寄件者: Chong Hermose [REDACTED]  
寄件日期: 2025年10月20日星期一 10:25  
收件者: tpbpd/PLAND  
副本: Andrea Wing Yin YAN/PLAND  
主旨: A/YL-KTN/1176 : 申請文件  
附件: A\_YL-KTN\_1176\_Approved FS\_Plan.pdf; A\_YL-KTN\_1176\_Approved  
Drainage Proposal..pdf; A\_YL-KTN\_1176\_補充資料 ( 運輸處 ) ..pdf

**1. Comments from DSD**

# TEMPORARY DRAINAGE PROPOSAL

Application Site of Proposed Temporary Private Club for a  
Period of 3 Years in Lot 130 Rp in D.D.110 and Adjoining  
Government Land, Kam Tin, Yuen Long, New Territories  
Issue 3 (November 2024)

Appendix B: Updated Site Photos (Nov 2024)

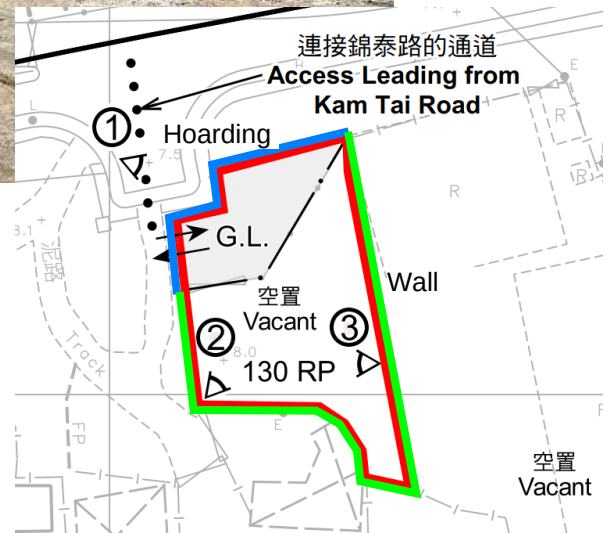
| <b>No.</b> | <b>Comments</b>                                                                                                                                                                                                                                                                                       | <b>Response</b>                                                                                                                                                                                                                                                                                                                                                      |
|------------|-------------------------------------------------------------------------------------------------------------------------------------------------------------------------------------------------------------------------------------------------------------------------------------------------------|----------------------------------------------------------------------------------------------------------------------------------------------------------------------------------------------------------------------------------------------------------------------------------------------------------------------------------------------------------------------|
| 6          | Please clarify whether any walls or hoarding would be erected along the site boundary. Where walls or hoarding are erected/laid along the site boundary, adequate opening (practically 100mm all along the wall) should be provided to intercept the existing overland flow passing through the site. | Please be clarified that hoarding and walls with adequate opening will be erected along the site boundary. Please refer to Appendix B with updated photos attached.                                                                                                                                                                                                  |

PROPOSED DRAINAGE WORKS

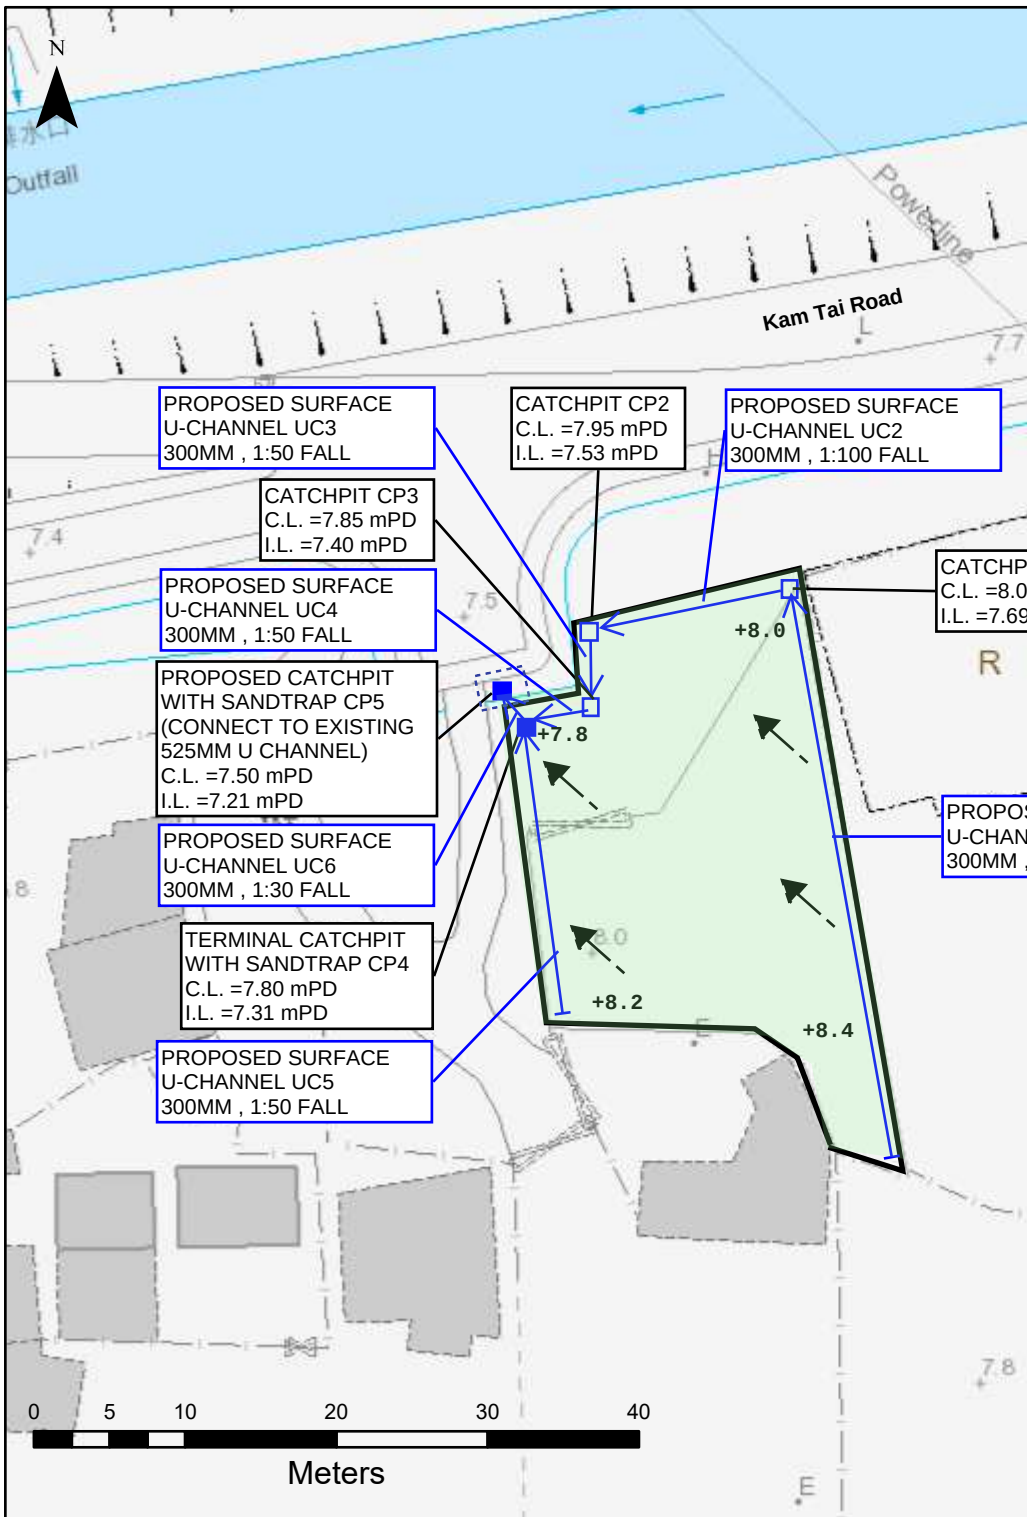
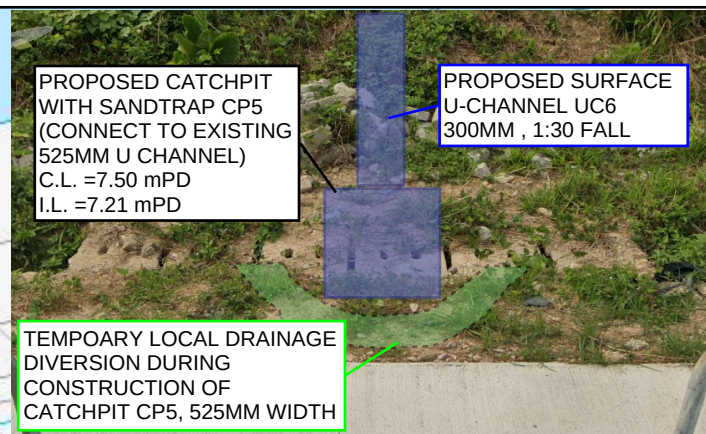
| <b>No.</b> | <b>Comments</b>                                                                                                                                                                                                                                                                                       | <b>Response</b>                                                                                                                                                                                                                                                                                                                                                      |
|------------|-------------------------------------------------------------------------------------------------------------------------------------------------------------------------------------------------------------------------------------------------------------------------------------------------------|----------------------------------------------------------------------------------------------------------------------------------------------------------------------------------------------------------------------------------------------------------------------------------------------------------------------------------------------------------------------|
| 4          | The cover and invert levels of the proposed u-channels and catchpits should be shown on the drainage plan.                                                                                                                                                                                            | Noted. Appendix D1 is updated.                                                                                                                                                                                                                                                                                                                                       |

| RUNOFF FLOW DIRECTION OF ADJACENT AREAS WITH SECTION MARKS                                                                                                       |            |

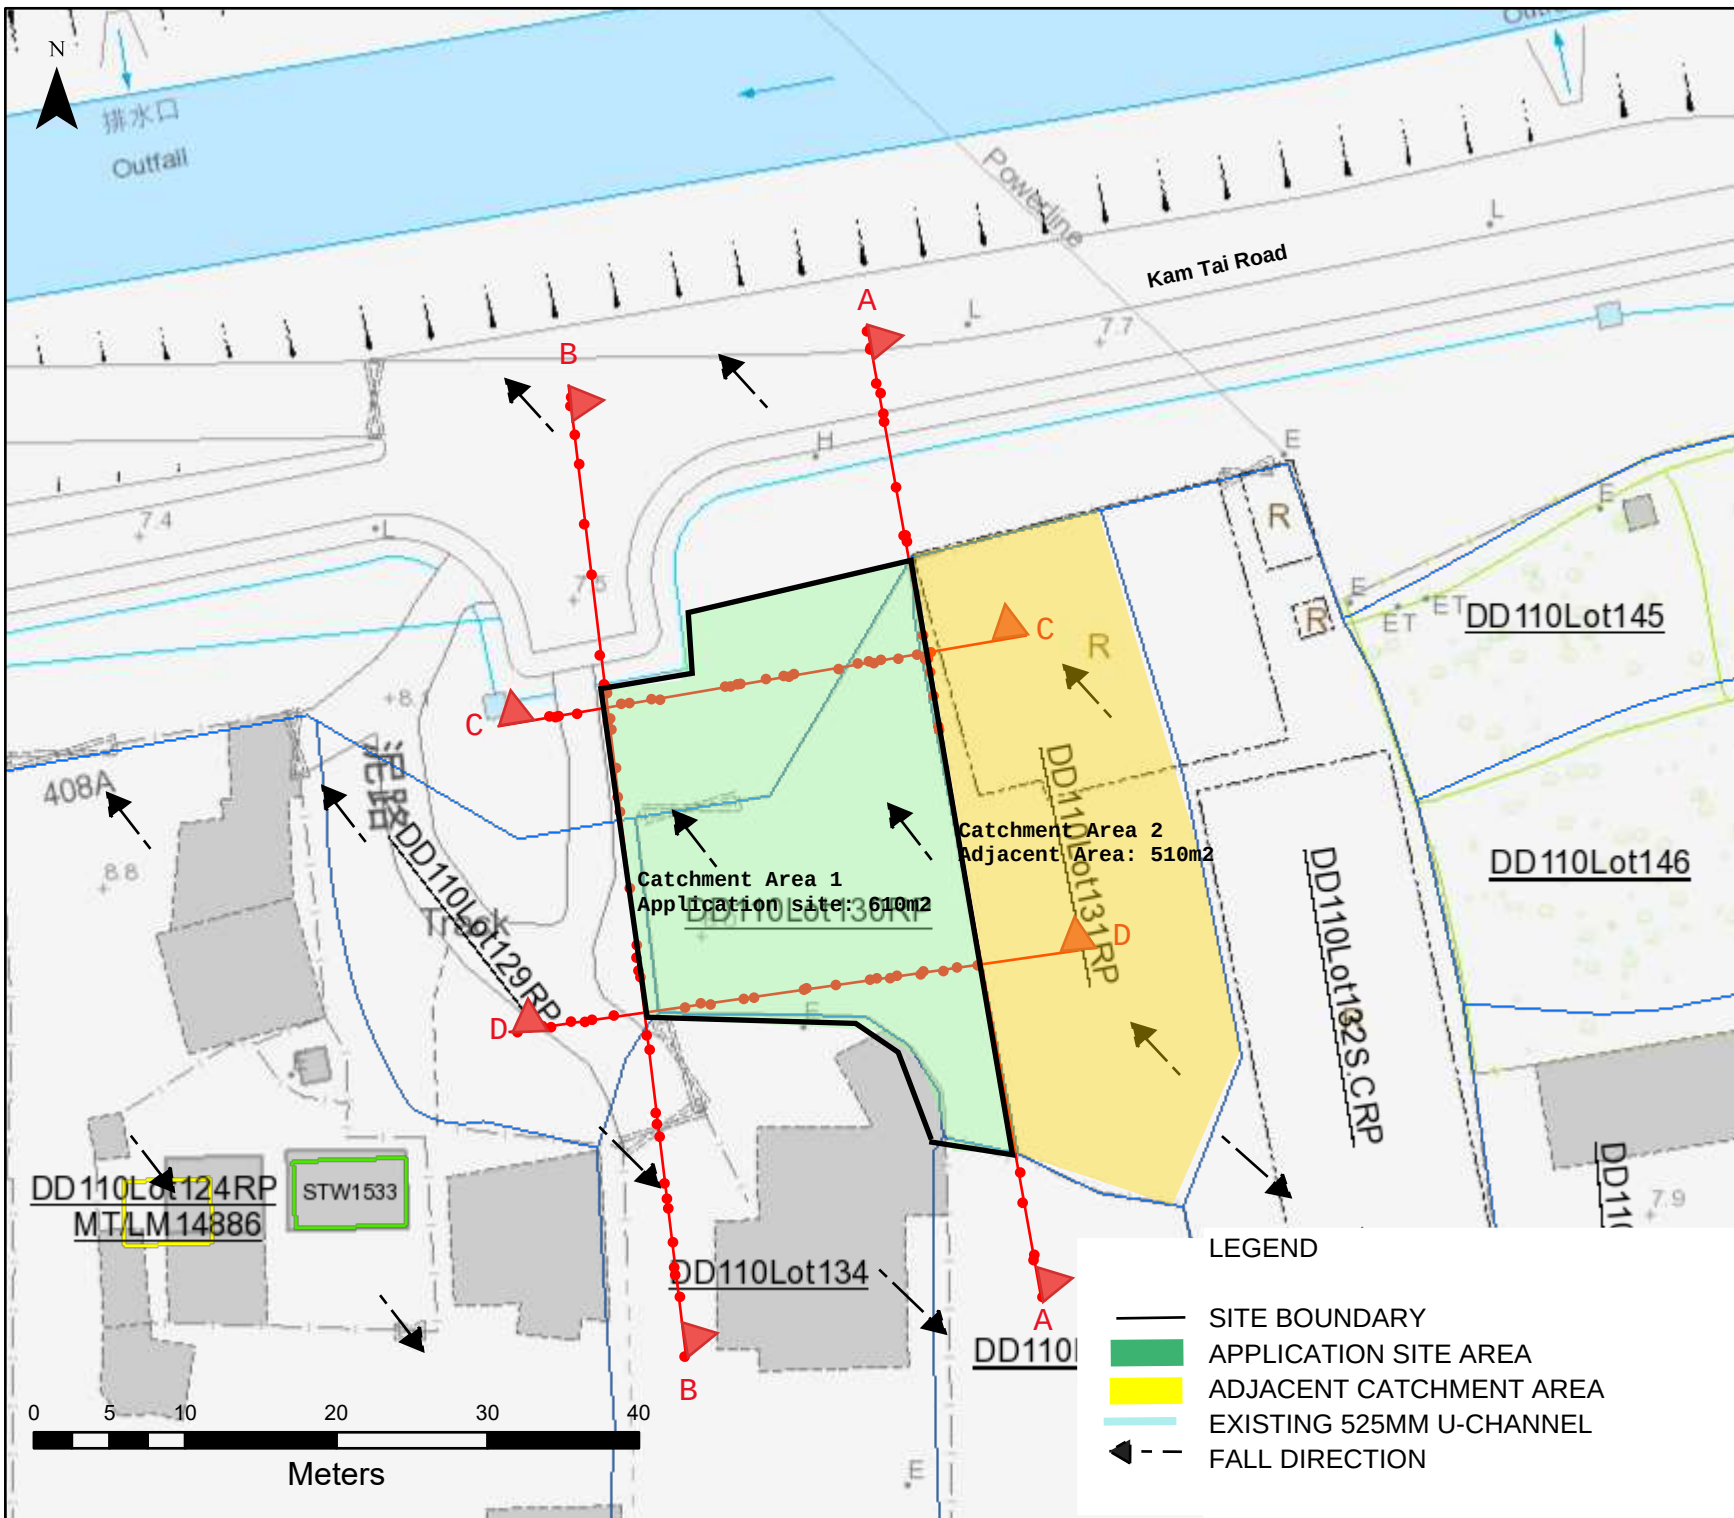
| <b>No.</b> | <b>Comments</b>                                                                                                                                                                                                                                                                                       | <b>Response</b>                                                                                                                                                                                                                                                                                                                                                      |
|------------|-------------------------------------------------------------------------------------------------------------------------------------------------------------------------------------------------------------------------------------------------------------------------------------------------------|----------------------------------------------------------------------------------------------------------------------------------------------------------------------------------------------------------------------------------------------------------------------------------------------------------------------------------------------------------------------|
| 5          | Please indicate the runoff (the flow direction) of the adjacent areas to show if there are any external catchment areas to be considered.                                                                                                                                                             | Noted. Appendix D2 is updated. It is noted that 510m <sup>2</sup> of adjacent catchment area may fall on the application site. For conservative approach, a total of 1120 m <sup>2</sup> (610 m <sup>2</sup> + 510 m <sup>2</sup> ) area are considered in the design calculation. 300mm surface channels are found adequate to capture the external surface runoff. |

## Appendix D1, 2 and 3

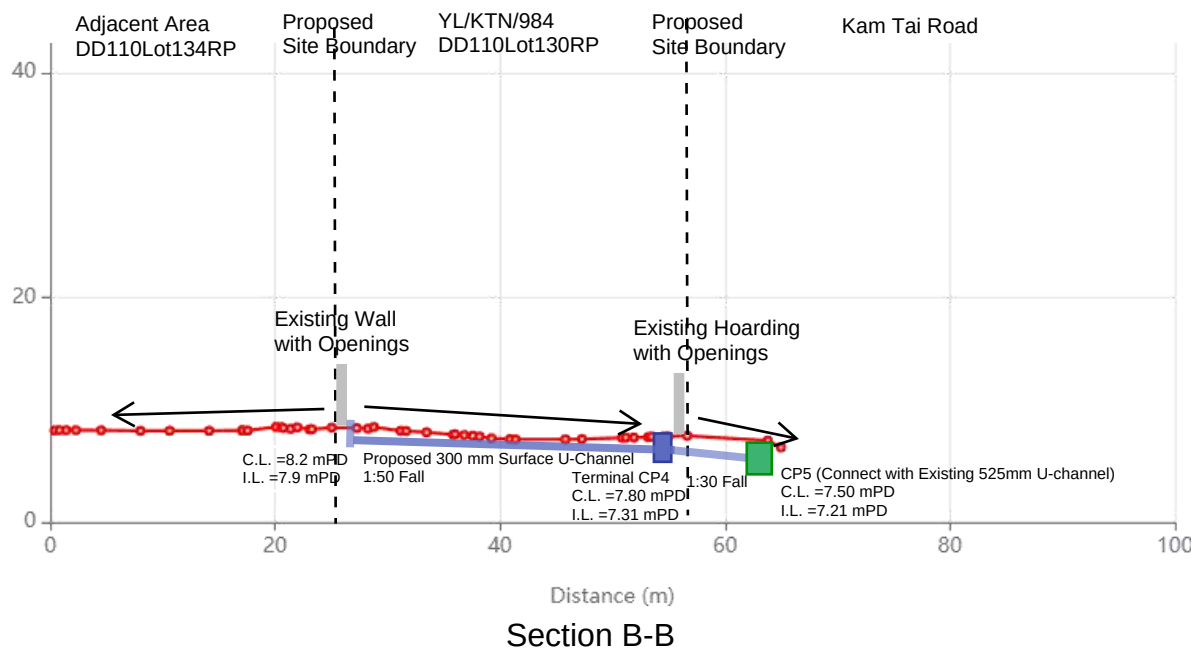
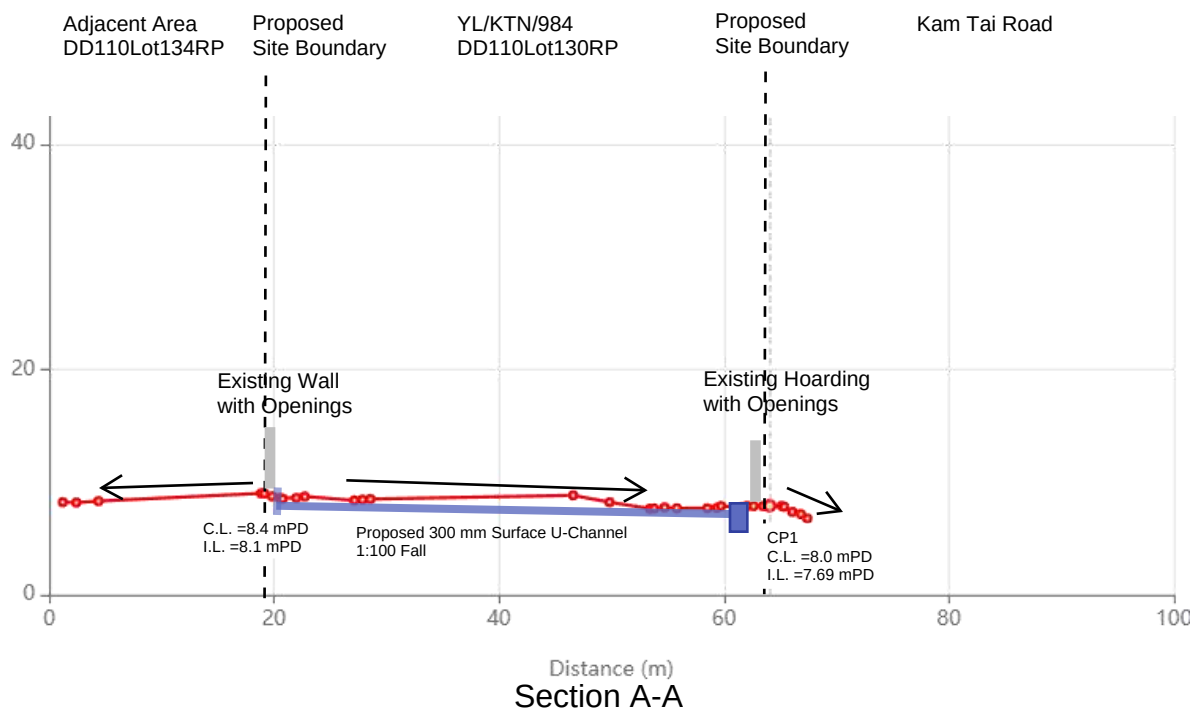
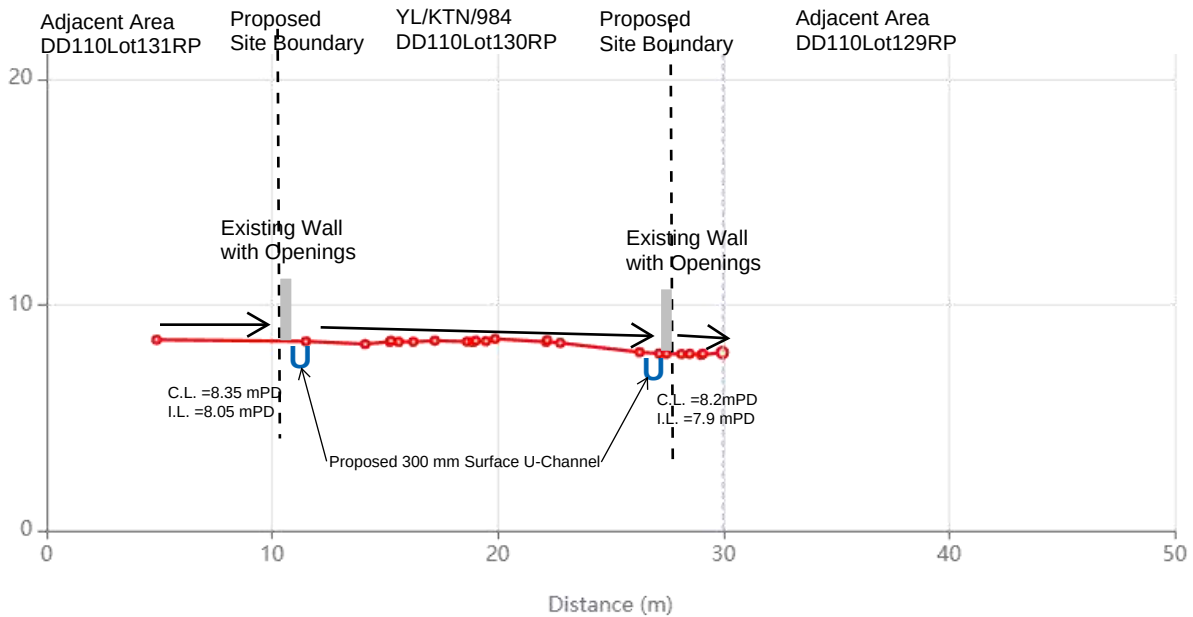
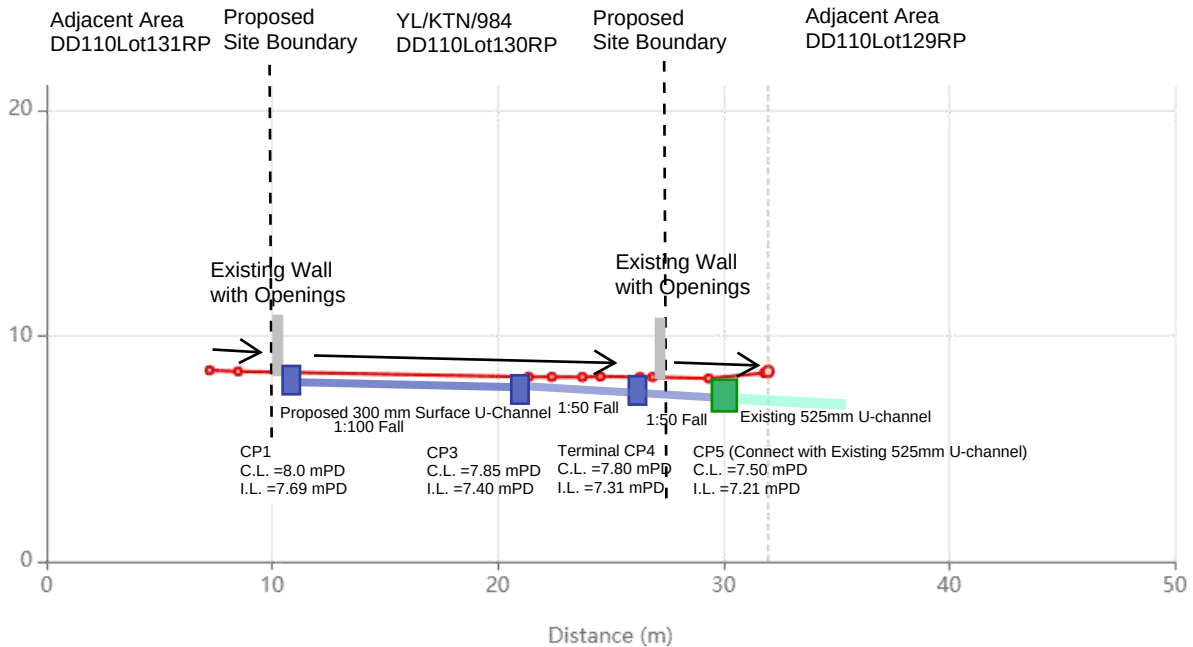
| <b>No.</b> | <b>Comments</b>                                                                                                                                                                                                                                                                                       | <b>Response</b>                                                                                                                                                                                                                                                                                                                                                      |
|------------|-------------------------------------------------------------------------------------------------------------------------------------------------------------------------------------------------------------------------------------------------------------------------------------------------------|----------------------------------------------------------------------------------------------------------------------------------------------------------------------------------------------------------------------------------------------------------------------------------------------------------------------------------------------------------------------|
| 7          | More cross sections in different directions showing the existing and proposed ground levels of the captioned site with respect to the adjacent areas should be given. Adjacent ground levels should also be shown in Section A-A.                                                                     | Noted. Section B-B, C-C and D-D are added in Appendix D3.                                                                                                                                                                                                                                                                                                            |
